Access Compliance Report

Public Rights-of-Way

(Curb Ramps)

Intersection ID: 10020415	Main Street: BALLANTYNE_MEDICAL_PL	Cross Street: N/A	Location: SE
ADA ID: B09FE5336EA4	Ramp Type: Perp	Initial Pass/Fail: Fail	Overall Compliance: No
Codes/Mitigation Info/Possible Solution		Field Measurements/Component Compliance	
Severity Score: 1.25

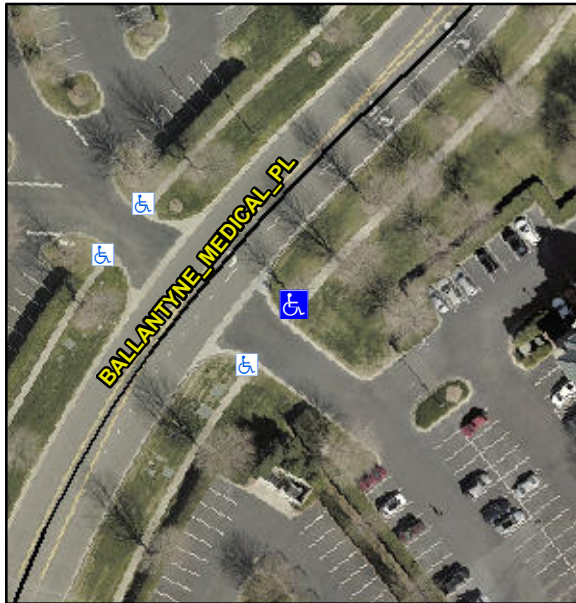
R304.5.3

Compliance	Description	Data	Compliance	Description	Data
N/A	Ramp Length (in)	72.0	Yes	Ramp Slope (%)	5.1
Yes	Ramp Width (in)	58.0	No	Ramp XSlope (%)	2.2
N/A	Flare Type LT	N/A	N/A	Flare Type RT	N/A
N/A	Flare Slope LT (%)	N/A	N/A	Flare Slope RT (%)	N/A
N/A	Flare Traversable LT?	N/A	N/A	Flare Traversable RT?	N/A
N/A	Landing Length (in)	N/A	N/A	DWS Provided?	N/A
N/A	Landing Width (in)	N/A	N/A	DWS Contrast?	N/A
N/A	Landing Slope (%)	N/A	N/A	DWS Length (in)	N/A
N/A	Landing X Slope (%)	N/A	N/A	DWS Full Width?	N/A
N/A	Landing Curb? (Y/N)	N/A	N/A	DWS Offset (in)	N/A
N/A	Shared Landing?	N/A			
N/A	Gutter Ponding?	N/A	N/A	Gutter Slope (%)	N/A
N/A	Gutter Lip Ht (in)	N/A	N/A	Gutter X Slope (%)	N/A
N/A	Painted X Walk1?	No	N/A	Painted X Walk2?	N/A
	X Walk 1 Direction	To SW		X Walk 2 Direction	N/A
N/A	X Walk 1 Width (in)	N/A	N/A	X Walk 2 Width (in)	N/A
	X Walk 1 Slope (%)	0.5		X Walk 2 Slope (%)	N/A
	X Walk 1 X Slope (%)	2.6		X Walk 2 X Slope (%)	N/A

Remove & Replace Entire Ramp.
